**SUBDIVISION, REZONING,
PLANNING APPROVAL, PUD &
SIDEWALK WAIVER STAFF REPORT****Date: May 3, 2007****APPLICANT NAME**

SUBDIVISION NAMEHighland Professional Park,
Resubdivision of Lots 2 & 3**LOCATION**6140 Airport Boulevard
(North side of Airport Boulevard, 150'± West of Highland
Woods Drive East)**CITY COUNCIL
DISTRICT**

SUBDIVISION PLAT

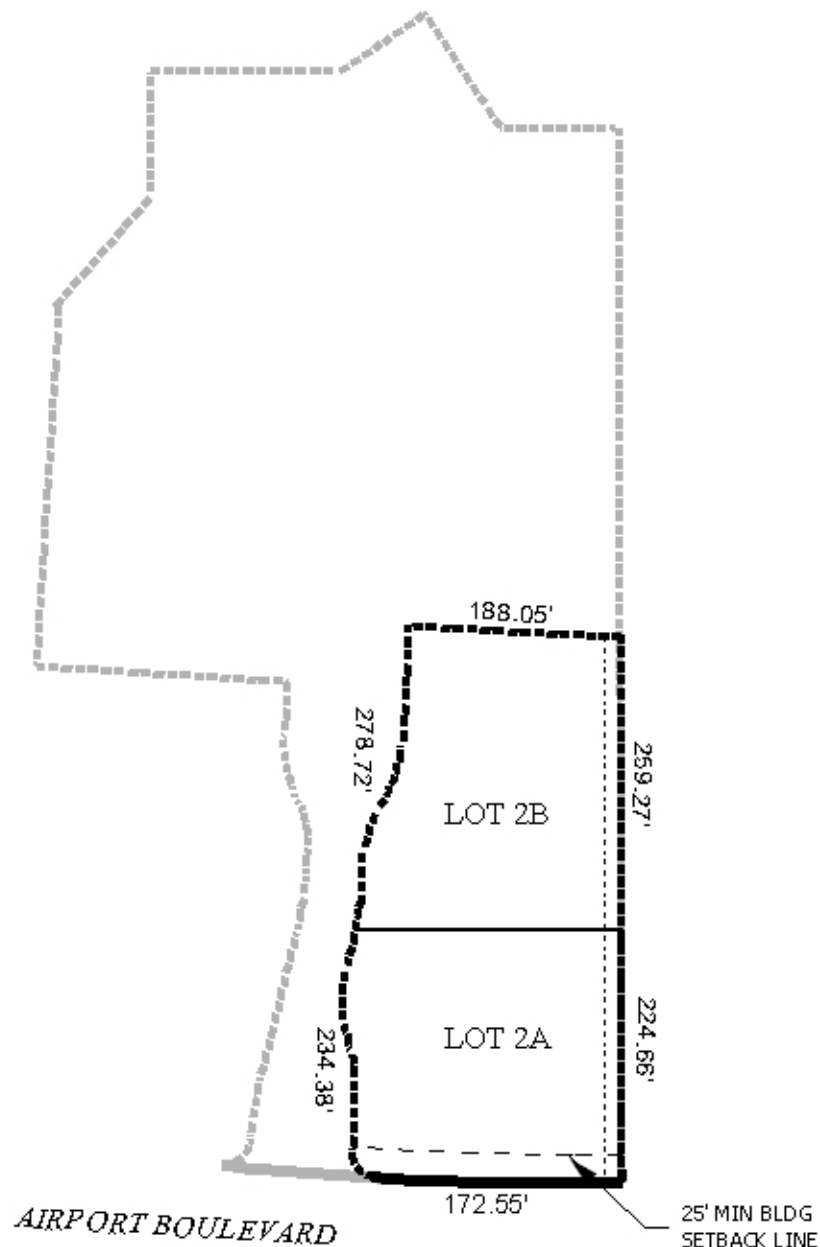
With regard to the proposed subdivision, the lots meet the minimum size requirements of the Subdivision Regulations. However, Lot 2B does not have frontage on a public street, and while the entrance boulevard functions as a private street and was constructed to City of Mobile standards, it does not meet the technical requirements of a private street because it is in fact a part of Lot 3 (of the original development) and not a private street right-of-way. As the subdivision and PUD were approved prior to the adoption of the private street standards of the Subdivision Regulations, consideration should be given to the functionality and construction standard of the entrance boulevard. If approved, a waiver of Section VIII.E.2.c. will be required.

Subdivision Based on the preceding, the application is recommended for Tentative Approval, subject to the following conditions:

- 1) provision of the 15' buffer along the East property line, as shown on the plat submitted, and required by the original approval;
- 2) placement of a note on the final plat stating that Lot is limited to a single one-way in drive from Airport Boulevard, size, location and design to be approved by Traffic Engineering; and
- 3) placement of a note on the final plat stating that any modification to the deceleration lane will require approval by the Traffic Engineering Department

SITE PLAN

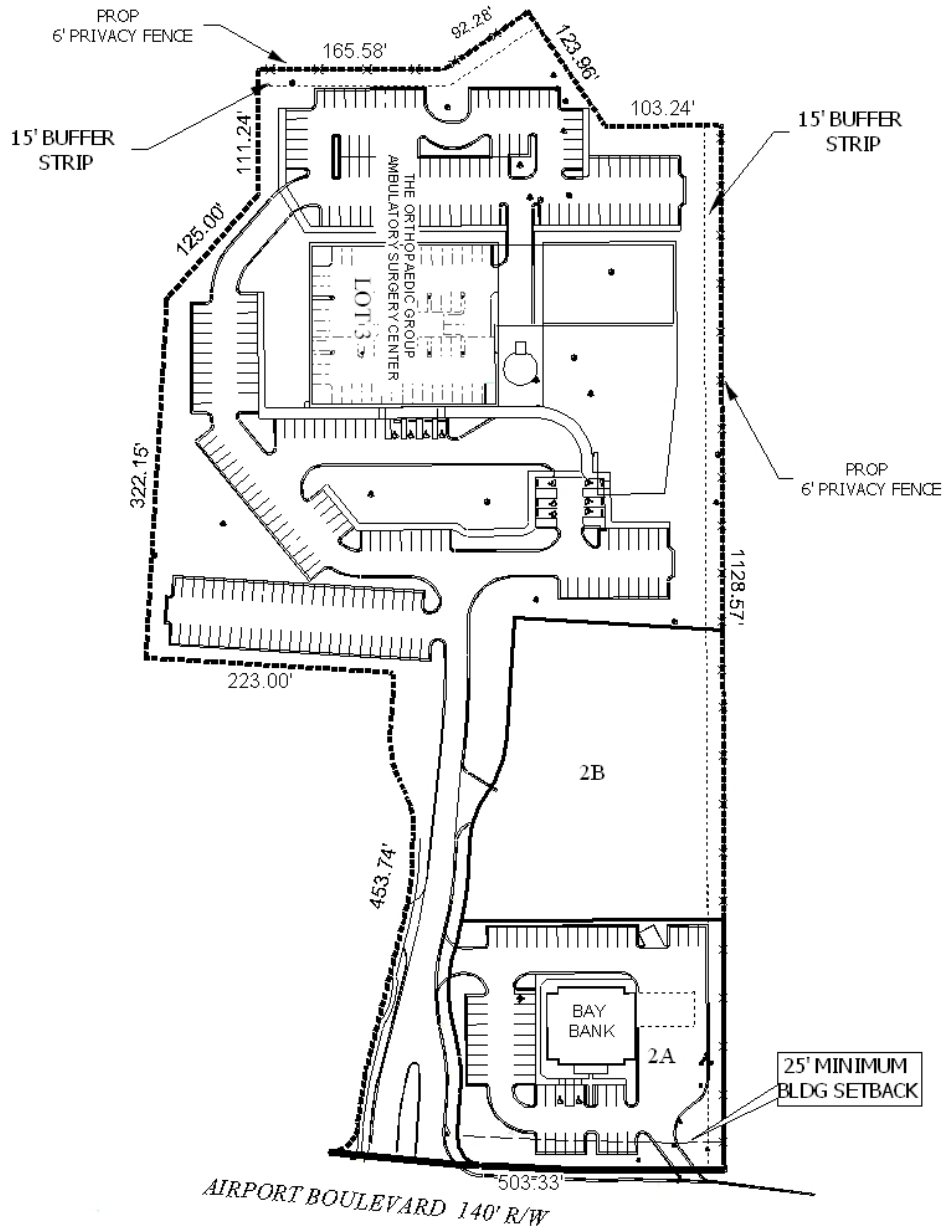
Storm water cannot be concentrated onto an adjacent property without a hold-harmless agreement. Must comply with all storm water and flood control ordinances. Any work performed in the right of way will require a right of way permit. Provide more information (cross section) for sidewalk waiver to be evaluated.

As the review for Planning Approval and PUD approval are similar, comments on these requests will be combined. Use of the site as a bank appears to be appropriate and compatible with existing development in the surrounding area. Additionally, the site proposes adequate parking and access, and internal circulation. The development would not generate traffic or congestion on neighboring residential streets.

The applicant states that the sidewalk along Airport Boulevard should be waived due existing power poles and light poles. The site plan submitted illustrates approximately 6' from property line to the power and light poles. This area should be adequate for the installation of a sidewalk, especially if there are no major topographic issues with which to contend. As there was no claim of such issue, nor submission of cross section (as required) to illustrate such issue, it would appear that the sidewalk could be constructed. Additionally, there is an existing sidewalk on the west side of the entrance boulevard.

- 1) limited to the site plan submitted, any significant modification will require new application(s) to the Planning Commission;
- 2) provision of the 15' buffer and 6' privacy fence along the East property line, as shown on the plan submitted (and required by the original approval), buffer area to be landscaped;
- 3) any modification to the deceleration lane will require approval by the Traffic Engineering Department; and
- 4) full compliance with all municipal codes and ordinances.

- 1) limited to the site plan submitted, any significant modification will require new application(s) to the Planning Commission;
- 2) provision of the 15' buffer and 6' privacy fence along the East property line, as shown on the plan submitted (and required by the original approval), buffer area to be landscaped;
- 3) any modification to the deceleration lane will require approval by the Traffic Engineering Department; and
- 4) full compliance with all municipal codes and ordinances.

Sidewalk Waiver: Based on the preceding, it is recommended that this application be denied.
